IESO's Preliminary Base Case Assumptions for the 2017 Long Term Energy Plan - Confidential

Prepared by: IESO

Date: February 7, 2017

Regarding item 16, the carbon price projection used in the OPO is the Bloomberg Auction Floor Price as shown in the chart below:

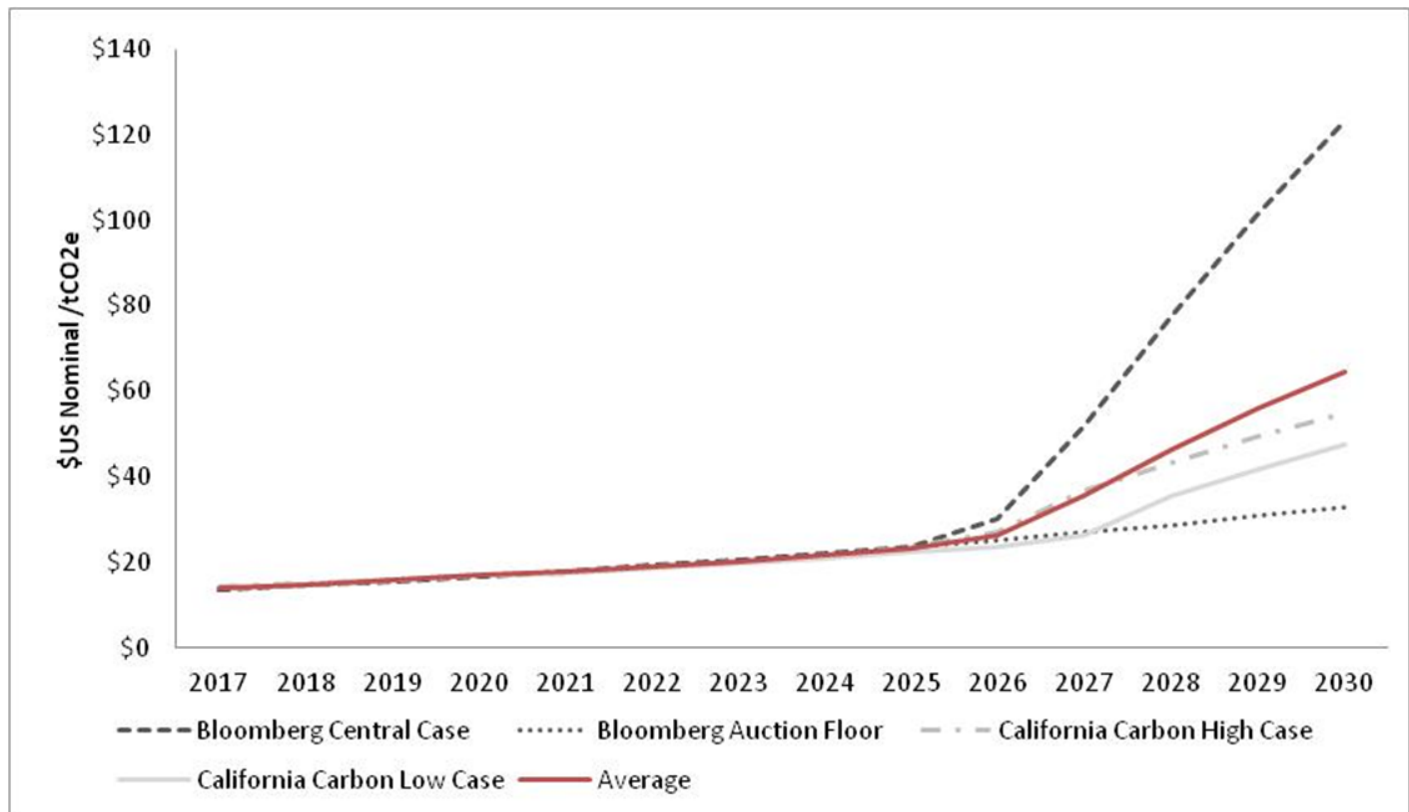
No attempt at this time to incorporate impacts of further rate mitigation initiatives currently being contemplated by government.	
16	Carbon cost assumptions in OPO is the Bloomberg auction floor price projection (see graph below for the carbon price forecast used). Seeking update from Ministry of Energy.	Direction Average forecast should be used.
17	Proceeds recycling to be included, if available.	Direction Proceeds recycling should not be included.
18	Update for actual 2016 residential billing data.

MOECC and MOE used the average of the various carbon price forecasts as shown by the red line for the cap and trade cost analysis with EnviroEconomics. However, the cost impacts after 2025 were not made public.
